Model: Adonis-C3	Date: 26-Jun-03	No.: MB082001a
------------------	-----------------	----------------

Serial Number Update

Modified Article: Pressure Roller		Prepared by: Y.Urushihara	
From: 1st Tech. Support Sec. Service Support Dept.			
Reason for Modification:	☐ Parts catalog correction ☐ To facilitate assembly ☐ Part standardization	☐ Vendor change ☒ To improve reliability ☐ Other	☐ To meet standards ()

Model: Adonis-C3	Date: 8-Sep-03	No.: MB082005a
------------------	----------------	----------------

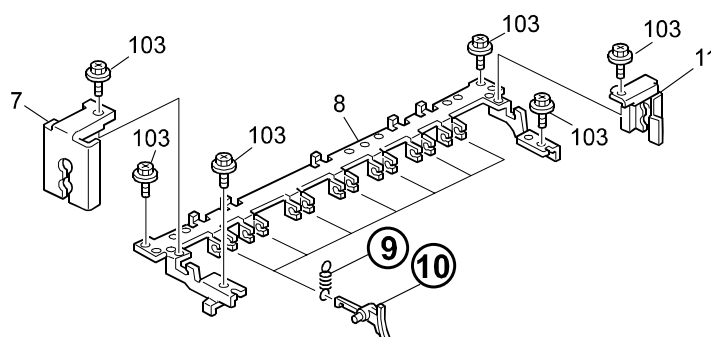
To minimize toner dropping onto copies from the Hot Roller Strippers, the width of the Hot Roller Stripper has been decreased from 3mm to 0.5mm and the pressure of the Tension Spring decreased from 300mN to 50mN.

Note: When installing for the first time, these parts should be changed **together as a set (X/O)**.

Model: Adonis-C3	Date: 26-Nov-03	No.: MB082007b
------------------	-----------------	----------------

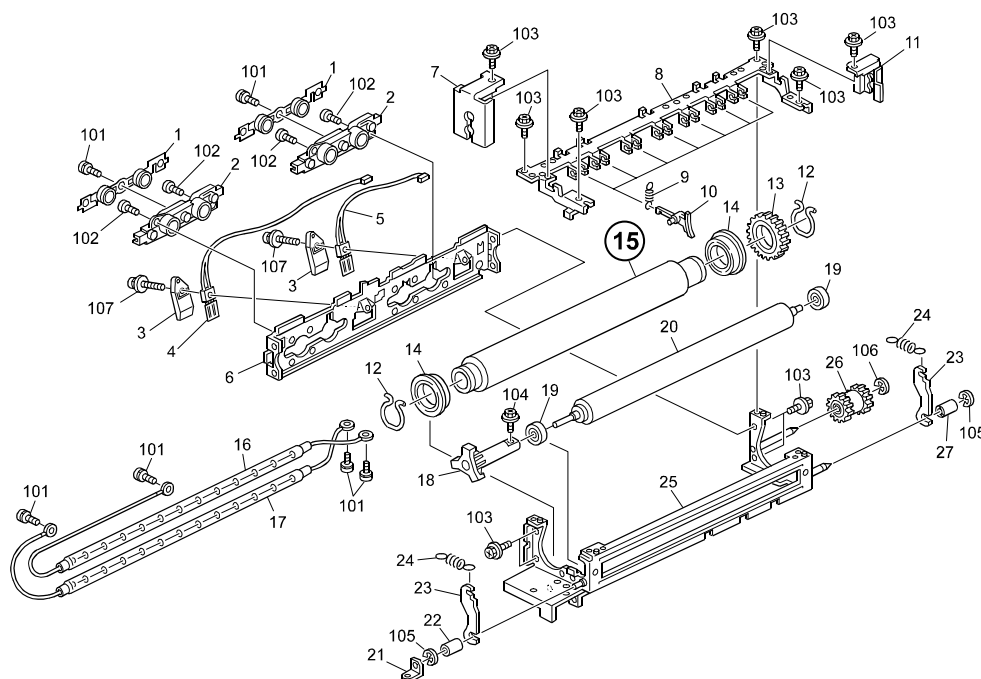
The following has been changed due to a vendor change.

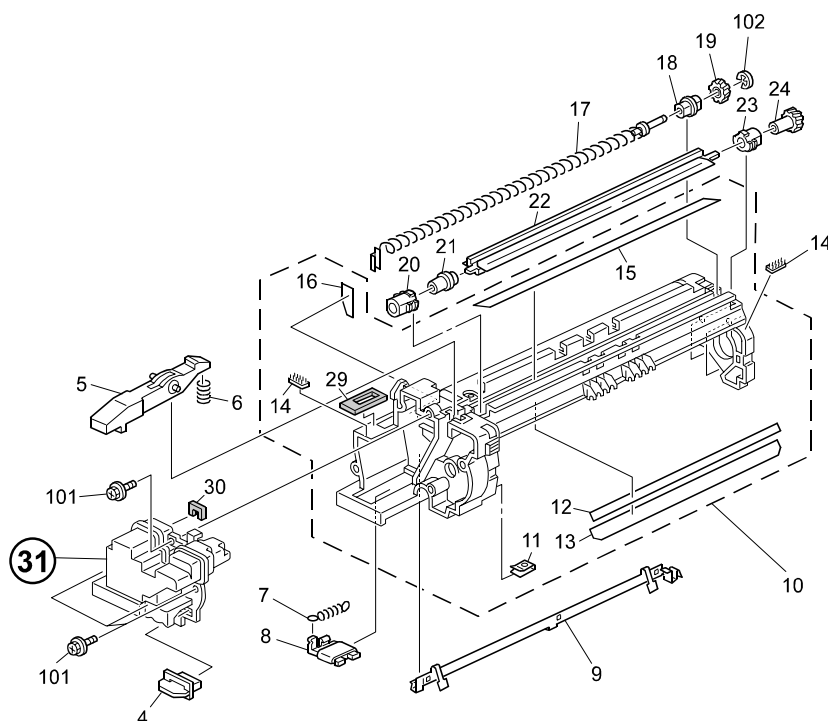
Please note the following revision made to the A-C3 Parts Catalog, which was applied from the beginning of mass production.

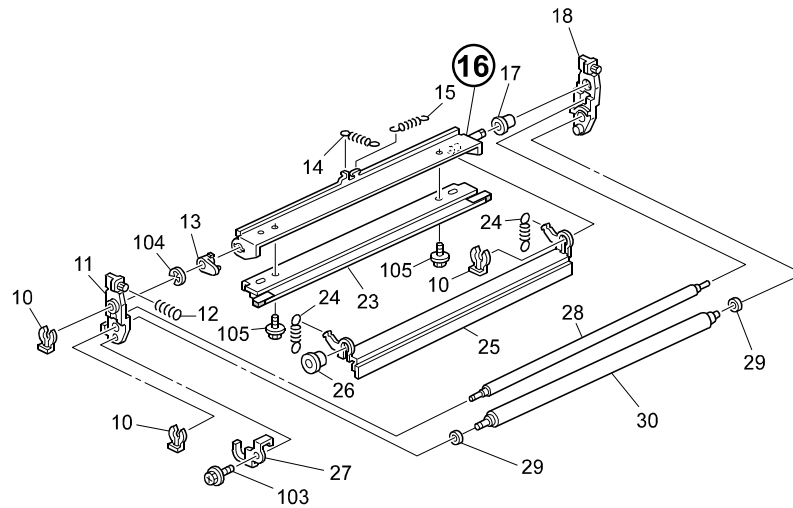
Please apply the following description correction to your Parts Catalogs.

Part Number	Incorrect Description	Correct Description	Q'ty	Int	Page	Index	Note
B0822312	Second Cleaning blade	Cleaning blade bracket	1-1		45	16

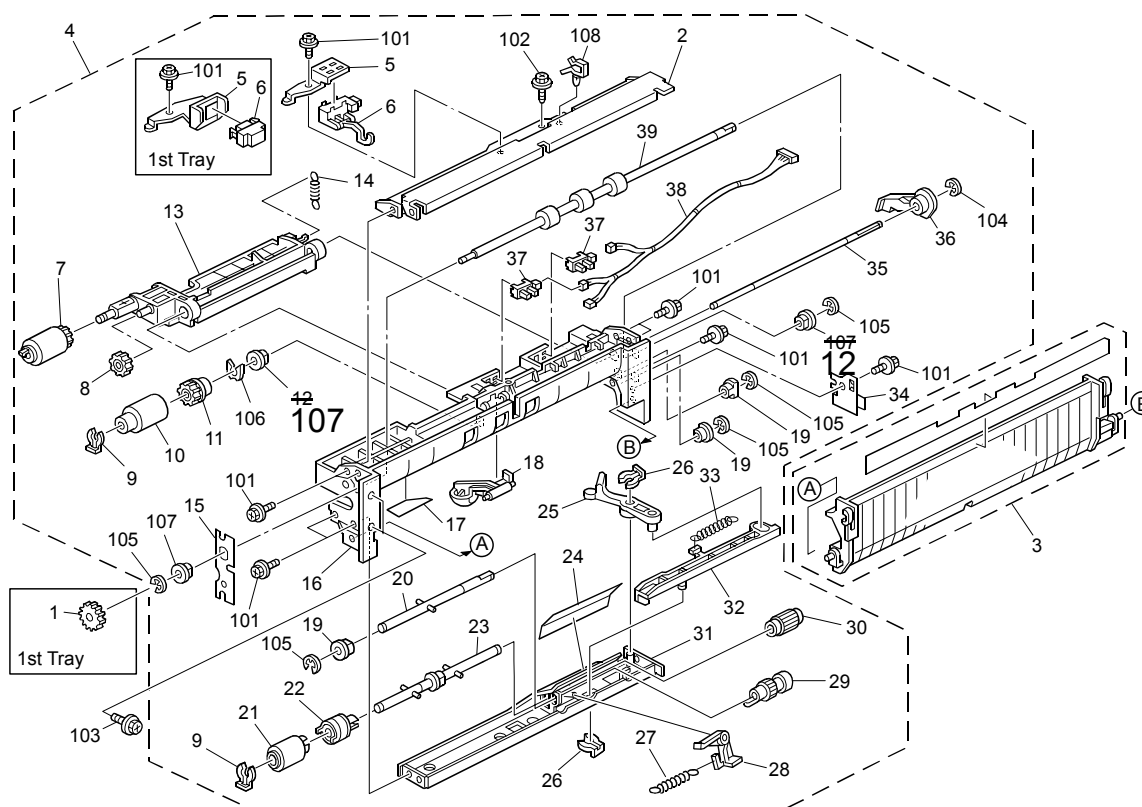
Please apply the following index number correction to your Parts Catalogs.

Part Number	Description	Q'ty	Int	Page	Incorrect Index	Correct Index	Note
AA082070	Bushing – 8x16x7	1		33	12	107	
08053480	Bushing – 6mm	-		33	107	12	(Right side of illustration only)

Important: Make sure to correct **only the large index numbers** shown below. All other index numbers are correct.

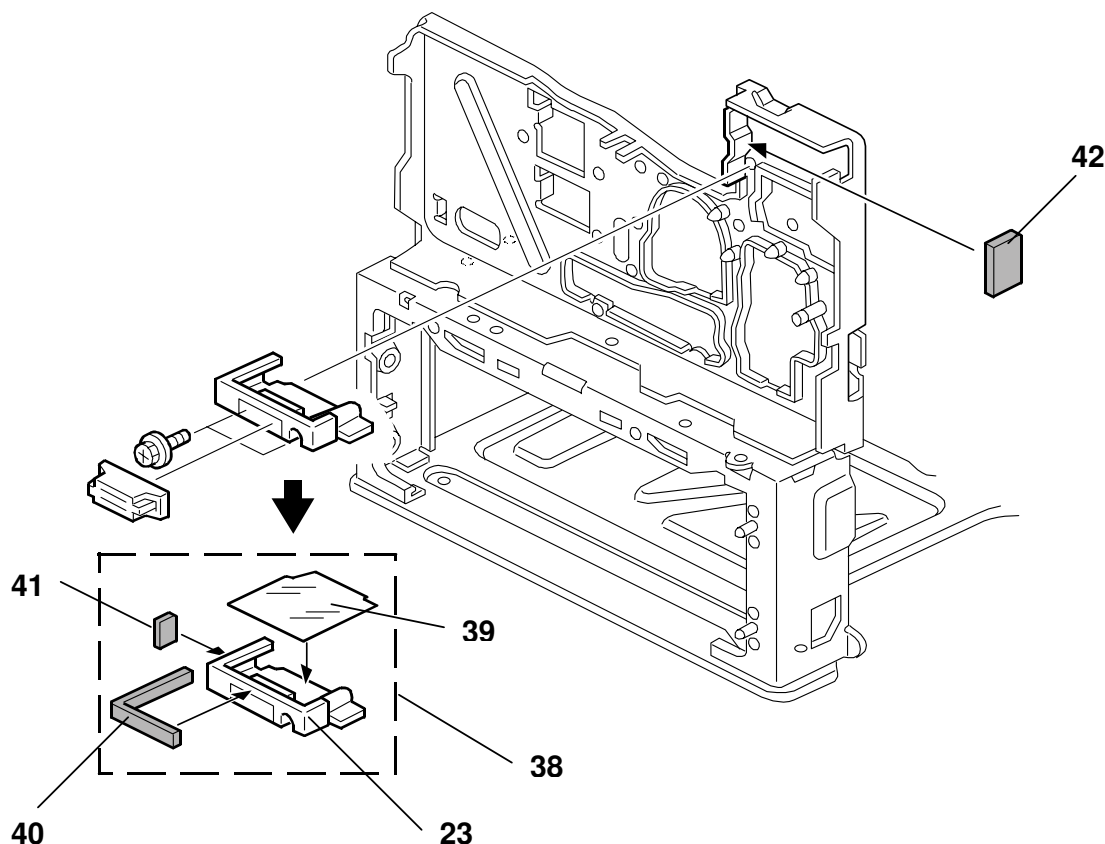
Change: Four seals were added to the upper inner cover and frame.

Reason: To ensure that toner does not cover the contacts of the upper right cover switch.

- This can cause random black lines along the main scan direction, a laser synchronization error, or "Door open" to be displayed.

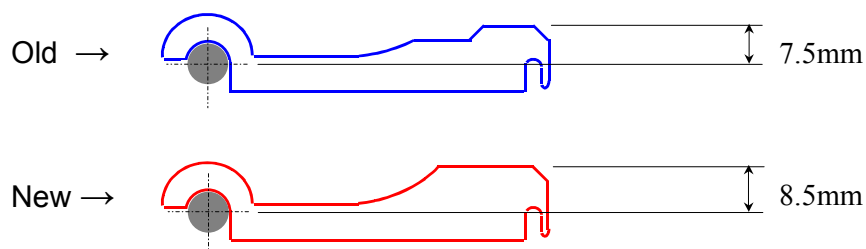
Change: Shape of the pressure lever.

Reason: To further ensure that the gap between the fusing hot roller and fusing pressure roller is normal.

Note: If the gap is too wide, streaks can occur on copies.

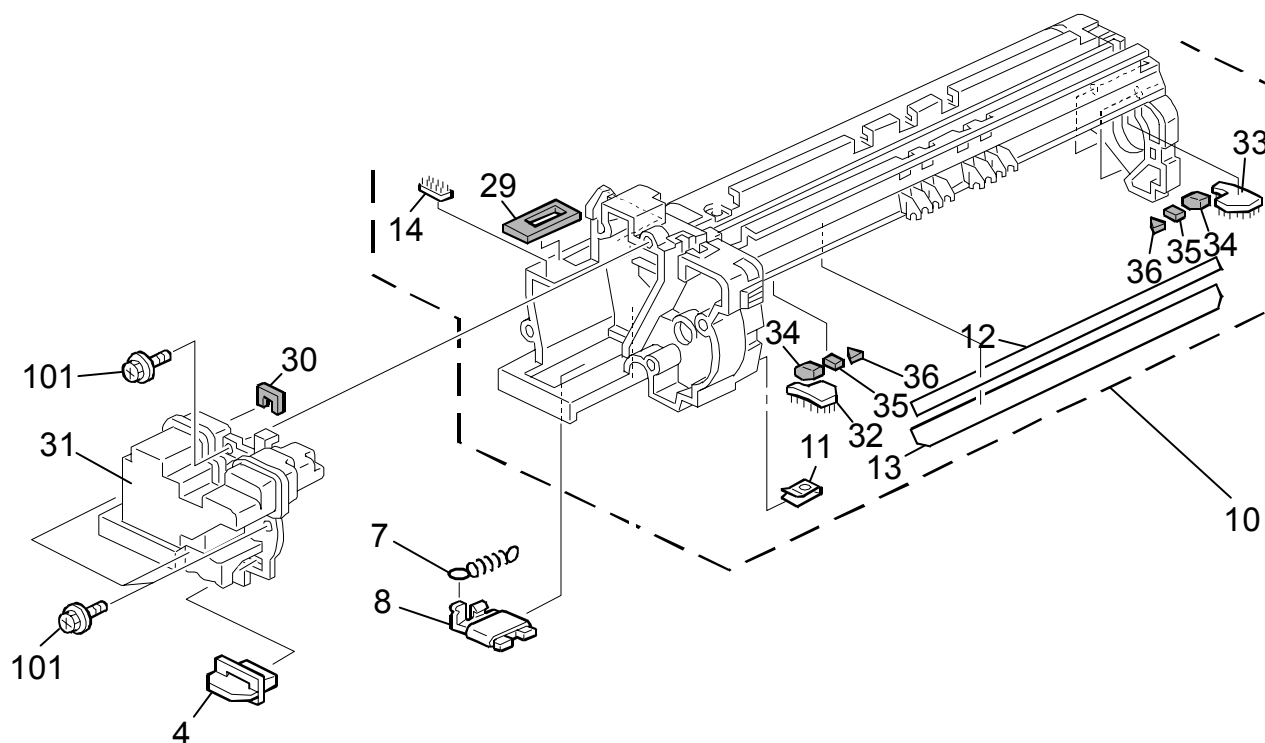
Part number	Description	Q'ty	Int	Page	Index	Note
G0652233	Seal Drum Front	1		43	32	
G0652234	Seal Drum Rear	1		43	33	
A2322399	Seal – Blade 13x9.5x3	2	-	43	34	
A2322348	Seal Blade 12x7x3	2	-	43	35	
A2322350	Seal - Entrance	2	-	43	36

Change/Reason: The descriptions for these parts were missing from the Parts Catalog.
